Application of	)
SPACE EXPLORATION HOLDINGS, LLC	) Call Signs S2983 and S3018
For Modification of Authorization for the SpaceX NGSO Satellite System	) File No. SAT-MOD-20200417-00037

## REPLY OF VIASAT, INC. IN SUPPORT OF ITS PETITION TO DENY OR DEFER

Figure 1: Debris Field 11 Years After Collision of Two LEO Satellites

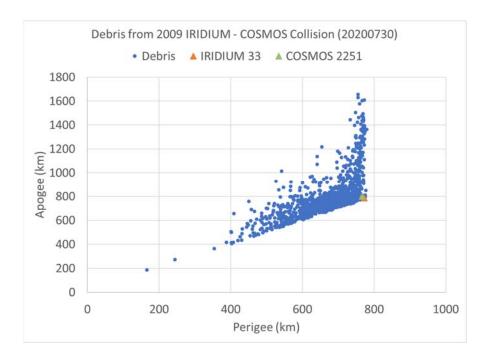
By way of example, if only two of the 10,000 satellites SpaceX expects to deploy over 15 years were to collide, we could expect a debris cloud similar to that of the 2009 collision between Iridium 33 and Cosmos 2251. The following figure shows that debris cloud as of a few days ago, 11 years after the event. There are still 1,380 trackable debris objects (typically > 10 cm) in orbit with apogees up to 1,656 km—orbital debris that have spread over 800 km above the orbits of the satellites involved in the original collision.

While SpaceX has designed its satellites for a specific area-to-mass ratio that can be factored into predicted passive decay times, the size and area-to-mass ratios of debris objects

Figure 2: Failures of v1.0 Starlink Satellites

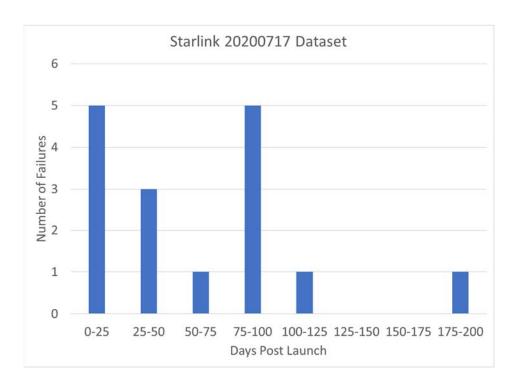
Using the Space-Track dataset from July 17, 2020, Viasat identified 16 apparent Starlink v1.0 satellite failures. The following histogram shows the distribution of failures with respect to days post-launch. Because more than one-half of the satellites in the dataset had been in orbit fewer than 120 days, Viasat does not know if the apparent predominance of early failures reflects infant mortality (*i.e.*, early failure), or is dominated by random failures with constant failure rate over the longer term.

On his Bad Starlinks website,<sup>57</sup> Jonathan McDowell<sup>58</sup> has identified 13 of the v1.0 Starlink satellites that he believes have failed (4 in decayed orbits plus 9 in decaying orbits), and 2 additional which have possibly failed. Elias Eccli's July update<sup>59</sup> (as of July 31) indicates that 20 of the v1.0 Starlink satellites have failed (4 in decayed orbits plus 16 non-operational), out of 478 launched. Whether the correct number is 13 (2.7% failed), 16 (3.4% failed), or 20 (4.2% failed), the apparent trend it troubling and is worse than SpaceX has reported.
